City of Albuquerque
P.O. BOX 1293 ALBUQUERQUE, NEW MEXICO 87103

DESIGN HYDROLOGY SECTION
123 Central NW, Albuquerque, NM 87102
(505) 765-7644

REF: GRADING AND DRAINAGE PLAN FOR PROPOSED ADDITION TO REPAIR SHOP
(J14-D9) RECEIVED JUNE 6, 1984

RE: Industrial Electric Equipment Service Drainage Report Addendum
Dated September 3, 1981 (File No. J-14-D 9)

PLAT NO. 1
INDUSTRIAL ELECTRIC EQUIPMENT SERVICE

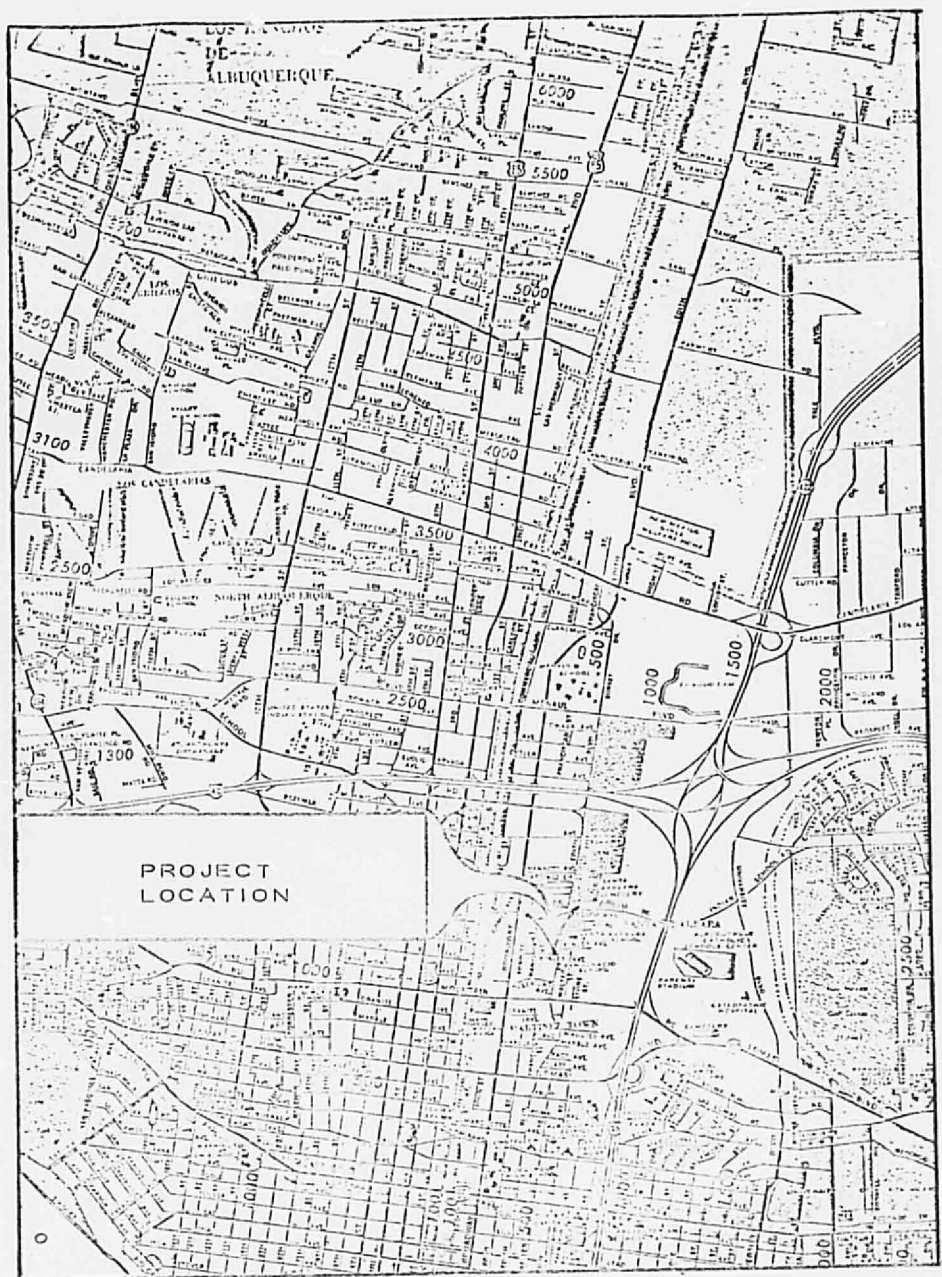
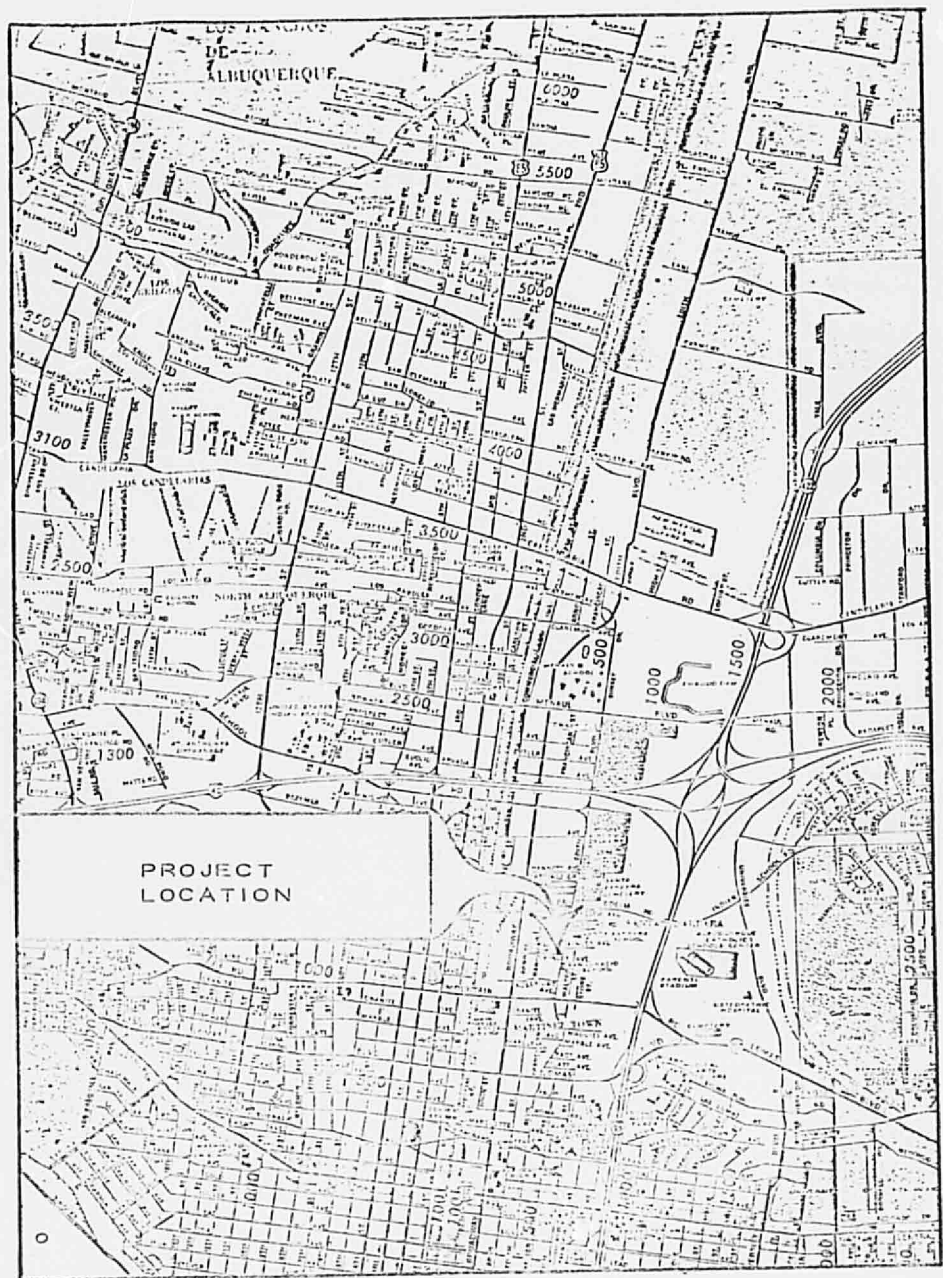
On the basis of the grading and the drainage plan submitted to this office, I find that I cannot agree with the results of the drainage report. My findings are as follows:

1. The area between the 6 foot chain link fence and the property line facing Franciscan Street was computed in 10,626 square feet. The paved and the roofed area amounts to 5,700 square feet. As indicated in the Handbook of Applied Hydrology, Ven Te Chow editor, the coefficients of runoff normally used (i.e. table 14-1 ref. cit.), are appropriate for the 5-10 year frequency storm. Multiplying factors are used for storms of lesser frequency. Please find attached a copy of the table adopted by the Denver Regional Council of Governments in their drainage criteria manual.

In the analysis of the runoff for the 100-year storm, a runoff of 0.35 is commonly adopted in the Albuquerque area, and for the impervious areas (roofs and pavements) a runoff coefficient of 1.0 needs to be used.

In accordance with the above given a 100-year frequency rainfall of 2.2 inches, using a runoff coefficient of 0.4 the undeveloped runoff volume would amount to 779 cubic feet. After development, the runoff volume would amount to 1,406 cubic feet with a total storage requirement of 627 cubic feet.

2. I notice that the ponding area provided appears located in part outside the property line (within Franciscan Street right-of-way?). If so, the pond would not be acceptable: ponding requirement must be located within the property without encroachment of public right-of-way (which is requested and dedicated for other public purposes).
3. The grading on the site as indicated does not insure the routing of the runoff through the pond. A good portion of the runoff can drain into the streets.

Please revise the drainage plan for the site to conform to the requirements above.
